1 **1.0 Reference: Exhibit B-1, B. BACKGROUND TO THE PROJECT, p. 1, paragraph 5**

8
9 **Q1.1 Please provide an explanation of FortisBC's operating guidelines for transformer**
10 **loading in per unit of continuous or nameplate rating and include Summer**
11 **Emergency and Winter Emergency ratings.**

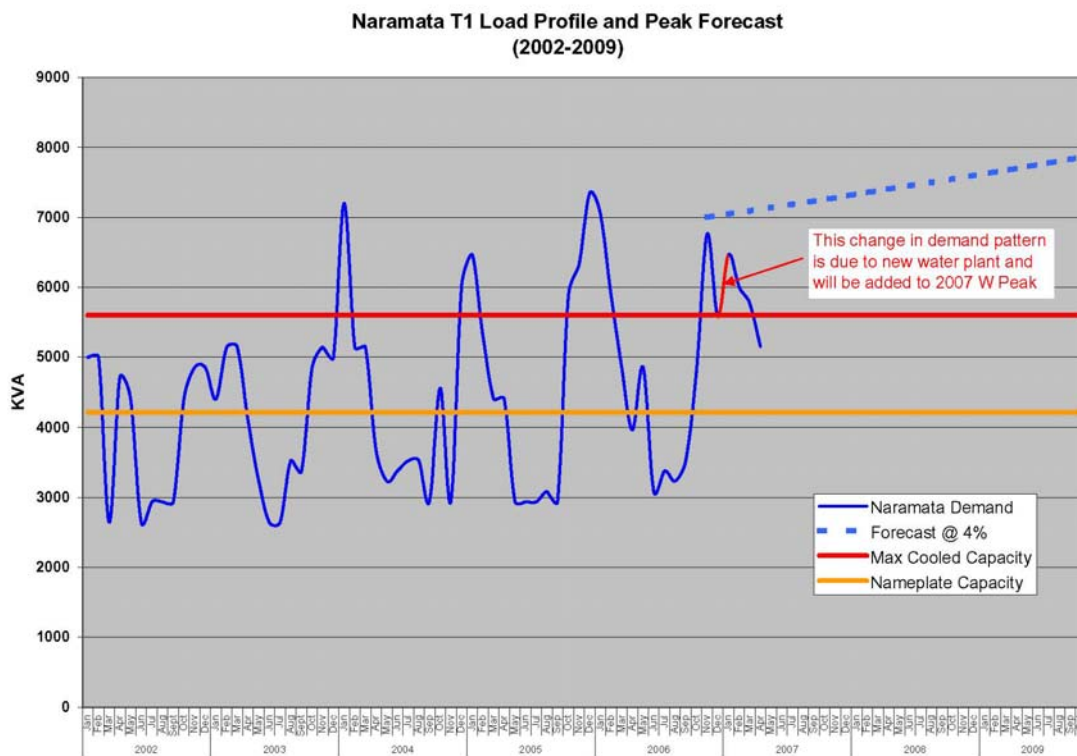
7
8 **Q4.2.1 In the 2005 Revenue Requirements, the forecasted electrical load growth is**
9 **stated as nearly 4%. What is the current forecasted electrical load growth**
10 **taking into account the predicted future and prior population growth (-0.2%**
11 **between 2001 and 2006 from Statistics Canada) in the area that this substation**
12 **will provide electrical service to?**

13 A4.2.1 Current forecast load growth is 3.4% based on a historical rate of 4.7%

14
15 The population growth rate cited in this question is based on population taken from
16 the 2006 and 2001 Census of Canada for Naramata. FortisBC is not aware of any
17 Statistics Canada population forecasts.
